RFI Response - 15 October 2021- Part One 757-763 George Street, Haymarket

RE: RESPONSE TO REQUEST FOR FURTHER INFORMATION - 757 - 763 GEORGE STREET, HAYMARKET

Figure 1 - Former Setback Arrangement

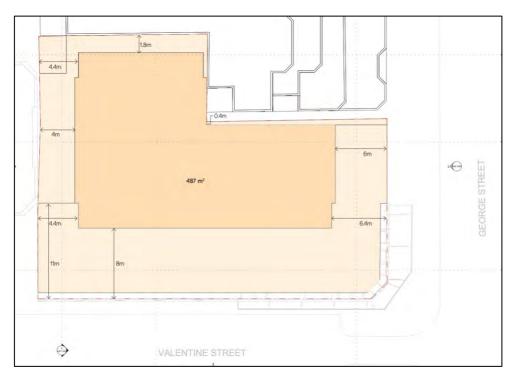
In accordance with Council's written request as outlined in the Request for Information letter (dated 22 February 2021), the northern setback has been revised to reflect the setbacks provided by Capitol Terrace. At its narrowest point, the northern setback to the common boundary reaches 1.6m. The building known as Capitol Terrace provides a 1.2m setback to its boundary. Combined, the total building separation between the two developments amounts to 2.8m.

A comparison between the former and revised setbacks is provided in the figures below and the Amended Architectural Plans at Attachment 1.

Figure 5 – Pedestrian Wind Environment Study

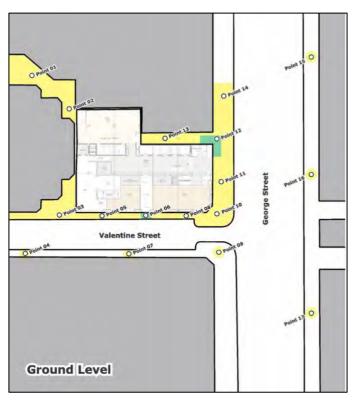
The wind assessment has been revised in response to Council's feedback. The assessment now accounts for additional testing locations that have been used to assess the pedestrian wind impacts at the southern end of George Street. These testing points relate to points 20 and 21 as shown in Attachment 4 and the figures below.

A revised Wind Impact Assessment has been prepared by Windtech and is included at Attachment 4. The assessment has been informed by Council's Draft DCP as exhibited alongside the Draft CSPS. It has been prepared to address the pedestrian wind testing requirements established by Procedure B of Schedule 11 and to assess whether the non-compliant northern and western setbacks result in worsened wind conditions relative a compliant envelope.
